Access Compliance Report Public Rights-of-Way (Curb Ramps)

Intersection ID: 13760	Main Street: EUCLID_AV	Cross Street: TEMPLETON_AV	Location: N
ADA ID: D9F6F3C108C5	Ramp Type: Perp	Initial Pass/Fail: Fail	Overall Compliance: No
			Severity Score: 1.25

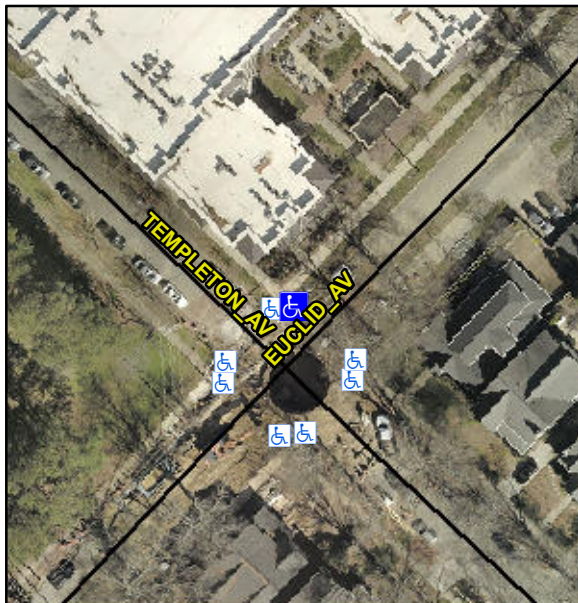
R304.5.3

Compliance	Description	Data	Compliance	Description	Data
N/A	Ramp Length (in)	79.0	Yes	Ramp Slope (%)	5.3
Yes	Ramp Width (in)	74.0	No	Ramp XSlope (%)	3.3
N/A	Flare Type LT	N/A	N/A	Flare Type RT	N/A
N/A	Flare Slope LT (%)	N/A	N/A	Flare Slope RT (%)	N/A
N/A	Flare Traversable LT?	N/A	N/A	Flare Traversable RT?	N/A
N/A	Landing Length (in)	N/A	N/A	DWS Provided?	N/A
N/A	Landing Width (in)	N/A	N/A	DWS Contrast?	N/A
N/A	Landing Slope (%)	N/A	N/A	DWS Length (in)	N/A
N/A	Landing X Slope (%)	N/A	N/A	DWS Full Width?	N/A
N/A	Landing Curb? (Y/N)	N/A	N/A	DWS Offset (in)	N/A
N/A	Shared Landing?	N/A			
N/A	Gutter Ponding?	N/A	N/A	Gutter Slope (%)	N/A
N/A	Gutter Lip Ht (in)	1.0	N/A	Gutter X Slope (%)	N/A
N/A	Painted X Walk1?	No	N/A	Painted X Walk2?	N/A
	X Walk 1 Direction	To SE		X Walk 2 Direction	N/A
N/A	X Walk 1 Width (in)	N/A	N/A	X Walk 2 Width (in)	N/A
	X Walk 1 Slope (%)	3.1		X Walk 2 Slope (%)	N/A
	X Walk 1 X Slope (%)	2.1		X Walk 2 X Slope (%)	N/A

Remove & Replace Entire Ramp.
